MAC address transparency

Norman Finn
Cisco Systems
Rev. 2

The Request for Interpretation

I wish to request an interpretation of IEEE Std. 802.1ad-2005. The relevant parts of the document are:

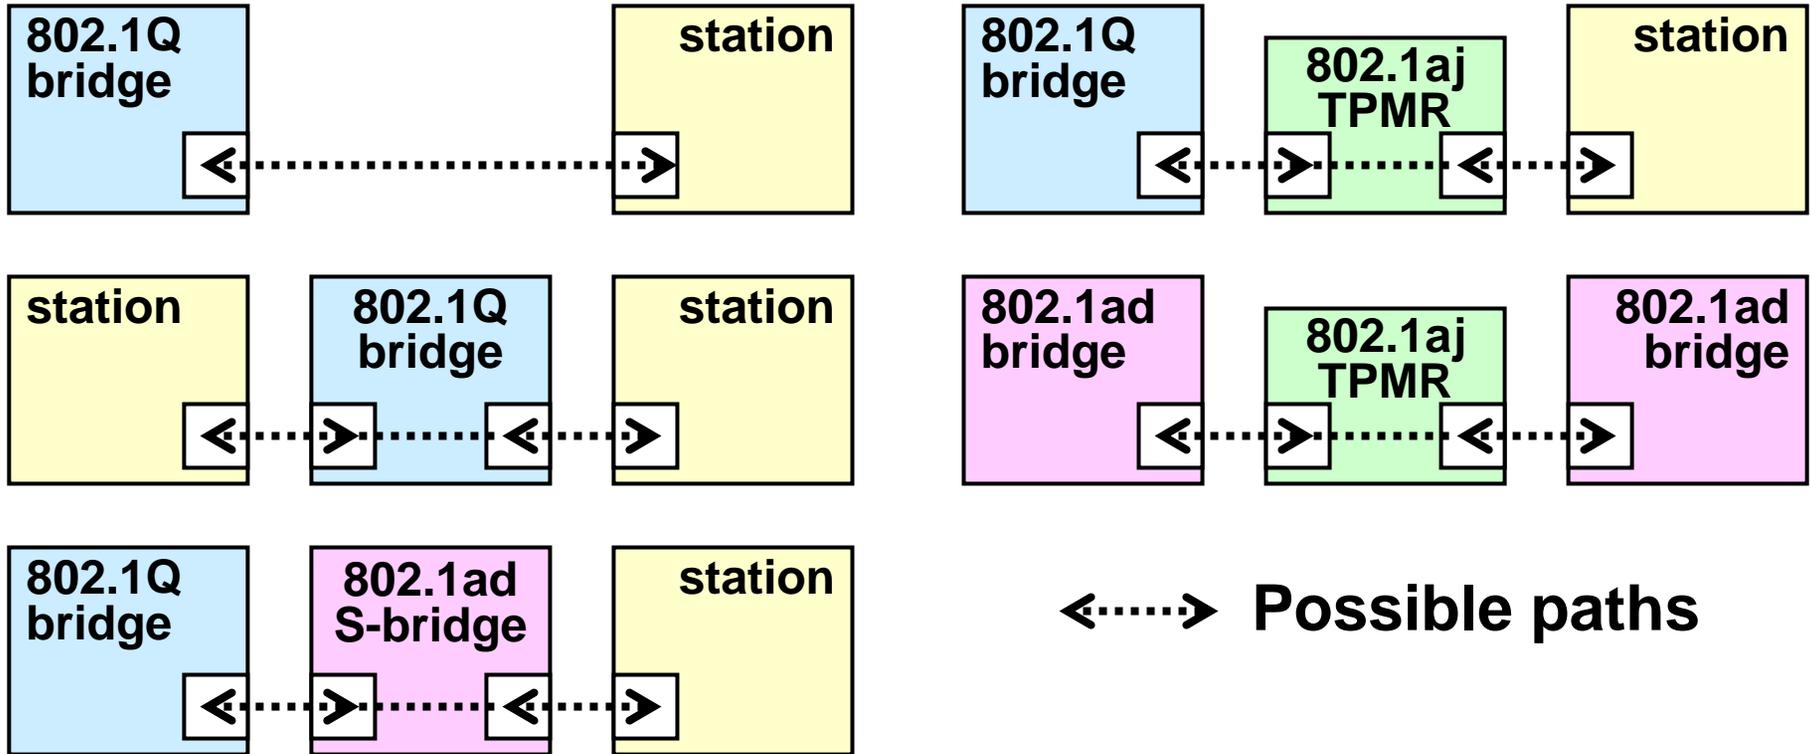
The expectation of 802.1AB, as expressed in point b) of subclause 1.2 and in the existence of the MAC/PHY Configuration/Status TLV, is that two systems A and B, each connected to a physical LAN, e.g. one complying with IEEE Std. 802.3-2002 Clause 25, and that are able to trade LLDPDUs (802.1AB Clause 4), can make use of the information carried in that TLV.

However, if the LANs to which A and B are connected are each connected to a Provider Bridge, so that A and B are separated by a Provider Bridged Network (802.1ad subclause 3.61), 802.1ad Table 8-2 indicates that A and B will still be able to trade LLDPDUs that use the standard destination MAC address 01-80-C2-00-00-0E. This defeats the purpose of the MAC/PHY Configuration/Status TLV, since these TLVs in the two systems’ LLDPDUs carry information about two separate LANs, instead of a single LAN.

The problem is therefore that the expectations of the users of 802.1AB are violated by 802.1ad networks. This could be corrected by altering 802.1ad Table 8-2 to include address 01-80-C2-00-00-0E. If this creates a problem, in that both addresses 01-80-C2-00-00-03 and ... -0E have the same reachability, then -03 could be removed from Table 8-2.

Relevant scenarios

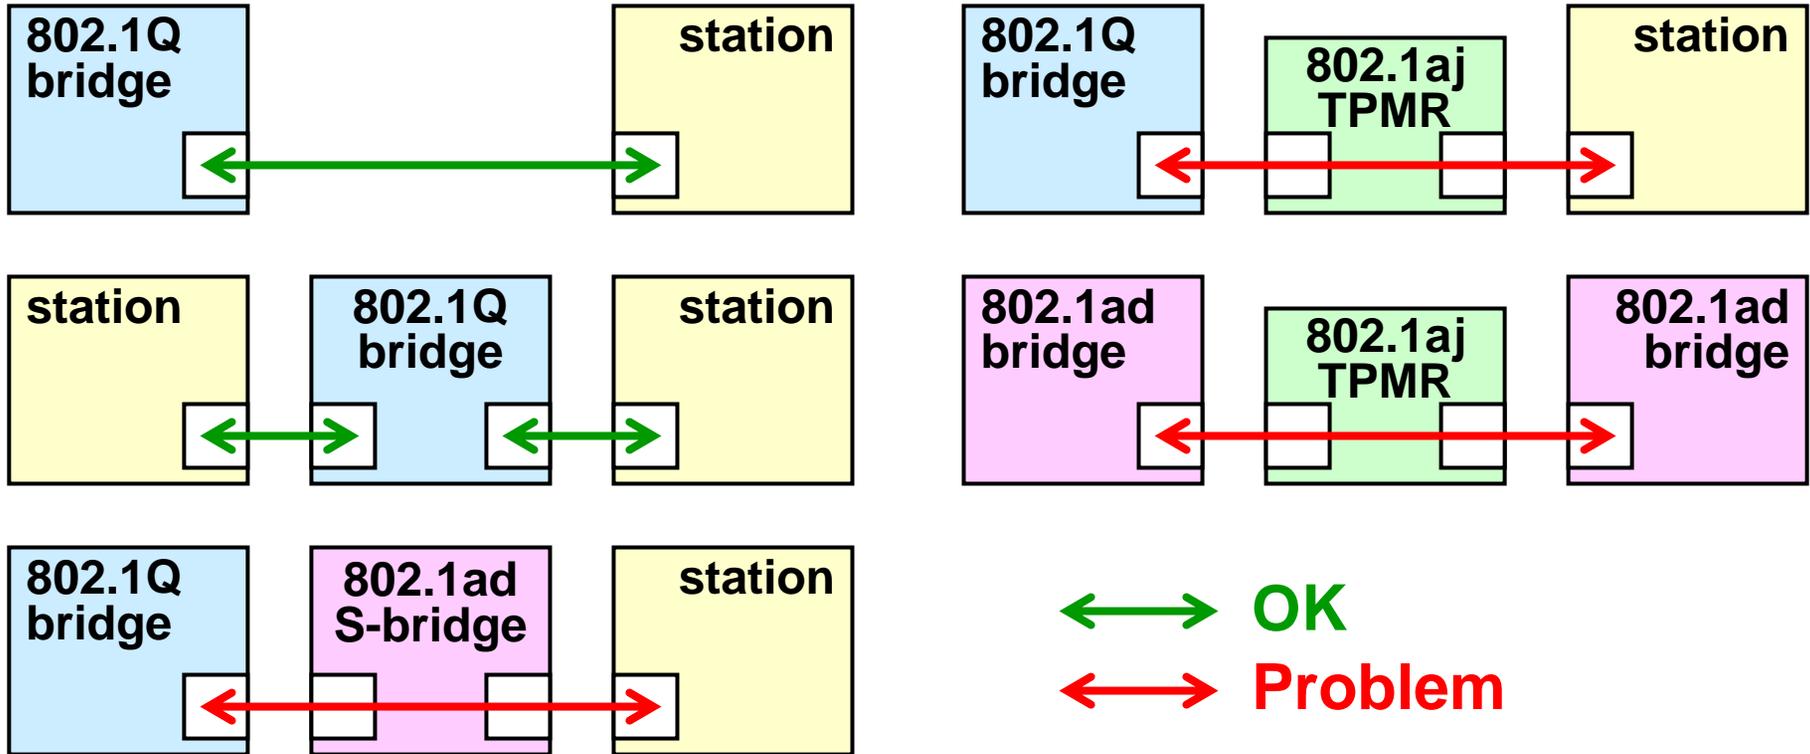
- How far does each address go?

- **Today:** address 01-80-C2-00-00-0E

Alternatives

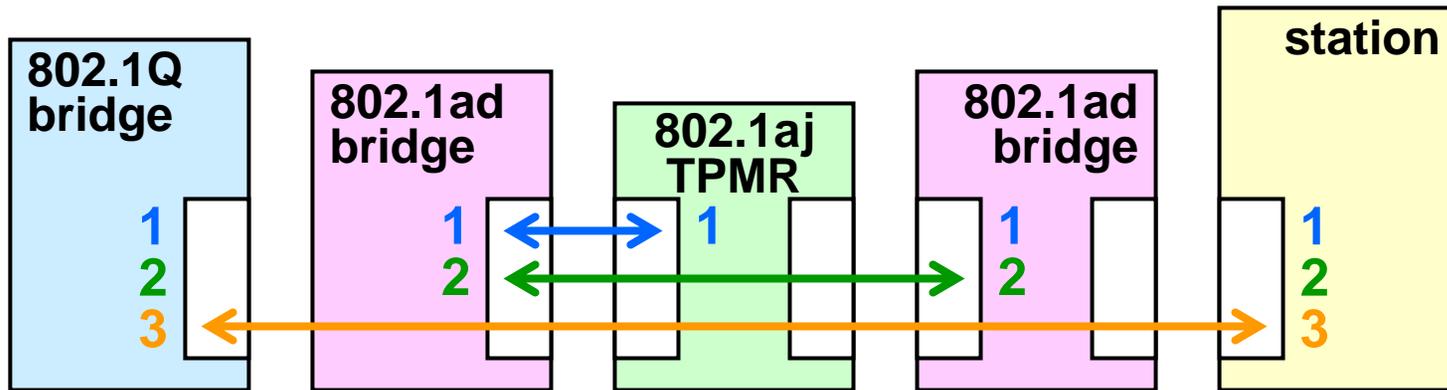
- 1. Change 802.1ad**, so that the existing LLDP address -0E is always physical.
 - This is problematical for existing Provider Bridges.
 - It leaves the phones and existing LLDP standard intact.
 - But, it is a quick fix to publish.
- 2. Change 802.1AB** to use another address for LLDP that is physical.
 - This is problematical for existing LLDP-aware phones and for T.R. 41.
 - It leaves Provider Bridges and 802.1ad intact.
 - But, it is not a quick fix to publish; MIB support for multiple addresses (reaches) and information on what TLVs go with what addresses are required.
